TND ENGINEERING  
TRAFFIC, TND, TRANSPORTATION AND CONSULTING

Re: Forest Hill Road (FHR)

I would like to offer your group some thoughts and additional analysis regarding FHR traffic and geometry.

A reduced copy of the chart is here, below, the trend lines are black:

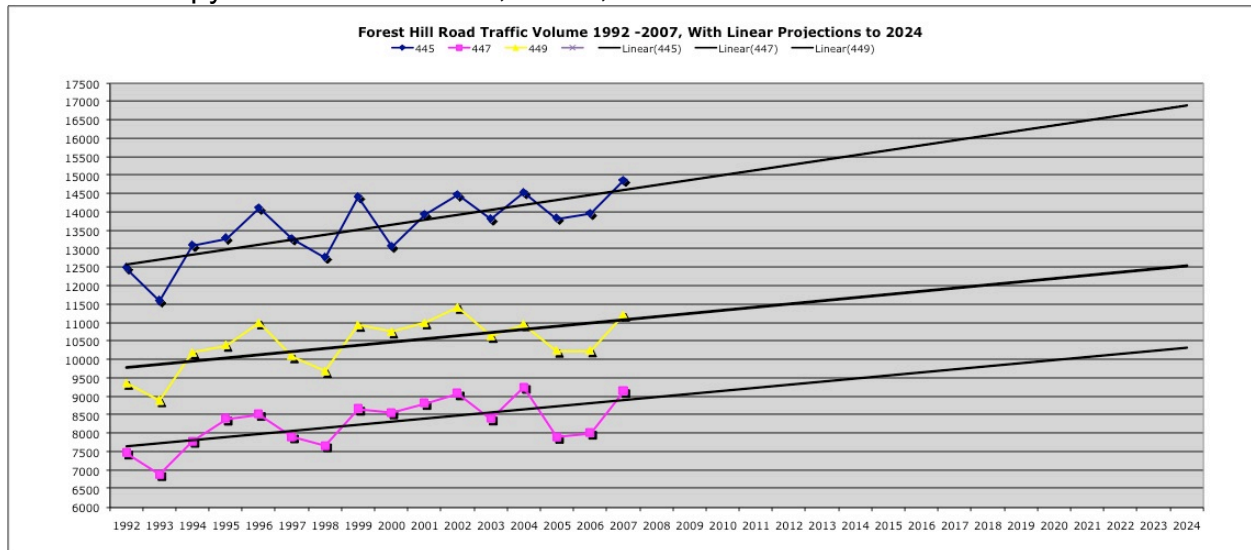
I have revisited this thorny matter in two ways: 2000 to 2007; and, 1992 to 2007. Only lower FHR South of Wimbish shows an upward trendline for both analysis scenarios.<sup>1</sup>

I have attached only the "FHR Traffic.pdf" file, because it does show some growth in traffic volumes for the 15 years and 16 data points from 1992 to 2007. Again, if one analyzes only the seven years and eight data points from 2000 to 2007, upper Wimbish shows no growth as a trend- this is important to remember when I revisit the potential realignment matter below.

Using the longer time period projects future traffic volume increases of approximately 14% for the highest and lowest volume portions of FHR (these being counters 445 and 447), and 12% for the area around counter 449.

The data shows 2024 projections to be 16,900 for lower FHR with additional future 2024 projections of 12,600 and 10,400 for the other sections. These compare with GaDOT projections of: 22,000 to 25,000; 21,300 and 15,650, respectively.

Stated differently and plainly: if a fair projection of the data from 1992 to 2007 is done, the results show the GaDOT projections to overstate the probable future results by 39% for lower FHR and 55% for upper FHR. These are **huge** differences and plainly show the need to revisit the fundamental assumptions about how FHR should be configured.

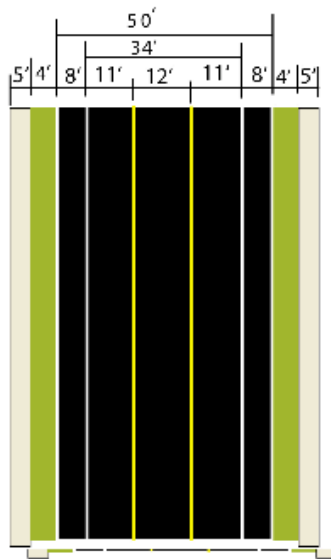
At the Macon Mediation, I proposed, and your group accepted, a proposal for upper FHR that was for two eleven-foot travel lanes with five-foot shoulders with an urban curb (pavement flush to face of curb on both sides of the street); a 32' curb-to-curb proposal (I am going to limit my comments here to the curb-to-curb issue only, as their appears to be agreement beyond the face of curb).

In the first reply, the County's representative(s) offered to reduce their proposed 38' plus 2' gutter pans, or 42' curb-to-curb (hereafter, c-c) dimension to a 36' c-c with the urban curb.

The County's most recent proposal- still in response to the Macon mediation day sketch, **not** the latest offer by your group, is a 32' +2'+2' gutter pan rural section with a 36' c-c. Both of the County's proposals have included a center two-way left turn lane and no shoulders.

### Forest Hill Road

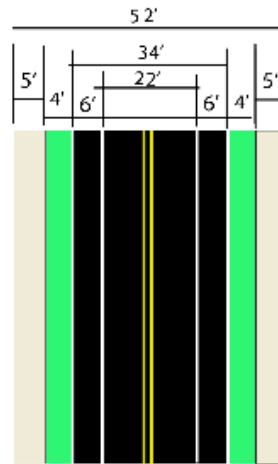
11' lanes beside 6' shoulders will definitely afford a slow deceleration area for right-turning cars, and enough room for cars to pass left-turning cars at slower and more appropriate speeds for a residential neighborhood (also see additional AASHTO support, below).

I recognize that this proposal goes “outside” the agreed area by including lower FHR, but for me the **significant** errors in the future traffic volume projections, coupled with the possible realignment of FHR and Wimbish compel the additional diagram.

I think the proposed three-lane section, with the addition of shoulders, is more appropriate for lower FHR, while the two-lane section, again with shoulders, will function more appropriately for upper FHR.
